Office Action Summary

10/796,406

AERTS, CHAD

DETAILED ACTION

Diagram A - Annotated Figure 3 of Miotto et al.

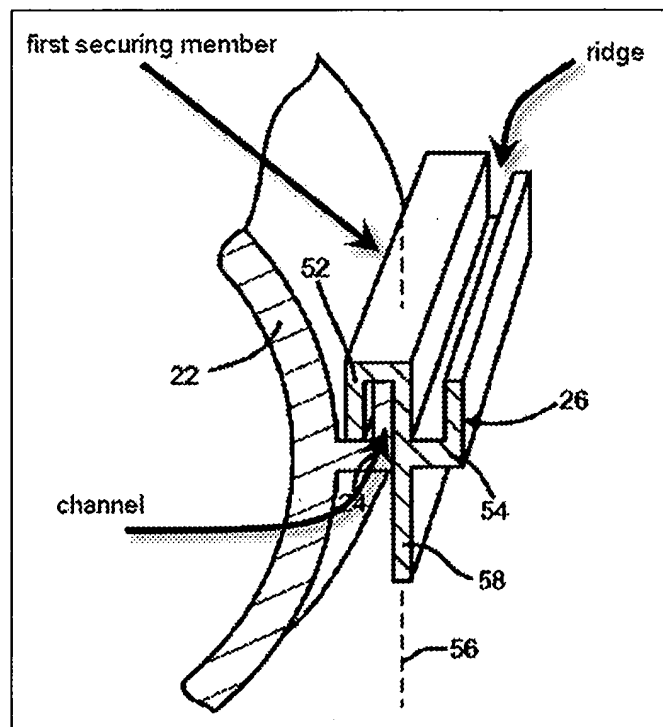
5. Applicant's arguments filed 15 March 2006 have been fully considered but they are not persuasive. With respect to claims 1 and 34, Applicant argues that furniture component of Miotto et al. does not teach the first securing member comprising a channel, a fabric piece disposed around at least a portion of the securing member, or a second securing member disposed around the first securing member with the fabric piece secured between the first and second securing members. Diagram A shows the configuration of the structural elements of Miotto et al. wherein the first securing

member has a channel, and Diagram B shows the fabric piece disposed around, i.e. enclosing, the tab portion 58 of the first securing member and the second securing member is disposed around the first securing member with the fabric piece secured between the first and second securing members.

Next, Applicant argues that neither the first securing member nor second securing member has a ridge. See Diagram A showing that the first securing member of Miotto et al. has a ridge.

Diagram B - Annotated Figure 2 of Miotto et al.

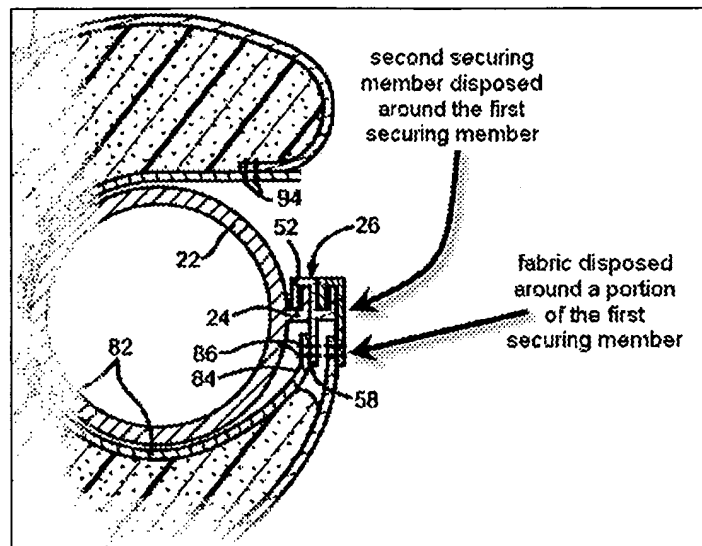
With respect to claim 31, Applicant argues that Miotto et al. does not disclose a securing member disposed between the base element and the fabric piece. Figure 2 of Miotto et al. clearly shows the fabric piece 80 disposed between the edge of the base element and the securing member 26.

With respect to claim 32, Applicant argues that Miotto et al. fails to teach a securing member with a ridge and a channel. See Figure 2 of Miotto et al. for the teaching the first securing member has a channel of the hook portion and a ridge extending below the third channel 54 that engages the fabric portion 88.

Diagram C - Annotated Embodiment of Miotto et al. shown in Figures 6 and 2

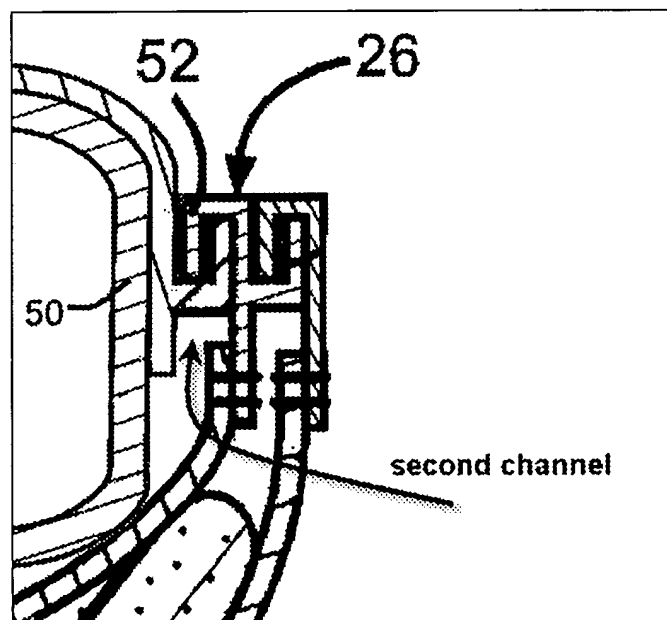
With respect to claim 14, Applicant argues that Miotto et al. fails to teach a fabric piece disposed within a channel. See Diagram C showing the channel housing the fabric piece.
